EXHIBIT A PROPOSED 101-C REVISION

EL DORADO COUNTY
 DEPARTMENT OF TRANSPORTATION
DESIGN STANDARDS

LOCAL ROADWAYS:
 RURAL REGIONS &
 RURAL CENTERS

STD. PLAN 101C

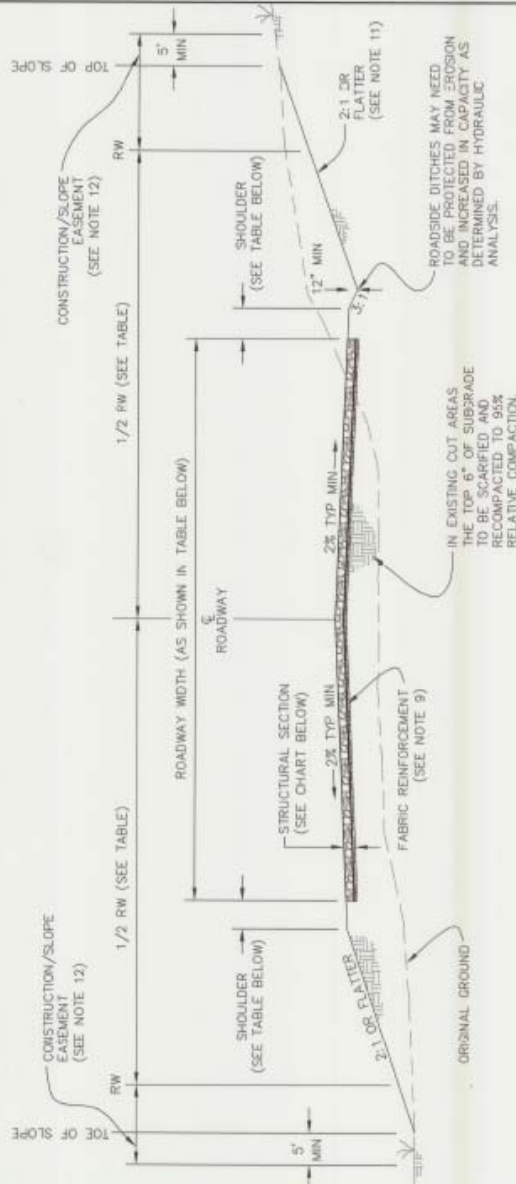
ADT	RW	ROADWAY WIDTH	SHOULDER WIDTH	DESIGN SPEED	MAX GRADE	STRUCTURAL SECTION
1-150	50'	18'	1' (EACH SIDE)	20 MPH	15% PAVED	6" CLASS 2 AB
151-600	50'	18'	2' (EACH SIDE)	25 MPH	12% UNPAVED *	(SEE NOTE 10)
601-1500	60'	20'	5' (EACH SIDE)	40 MPH	13% *	4" AC ON 7" AB
1501-2000	60'	22'	6' (EACH SIDE)	40 MPH		4" AC ON 8" AB

* 15% WITH COUNTY ENGINEER'S APPROVAL (NOT TO EXCEED 600 L.F.)
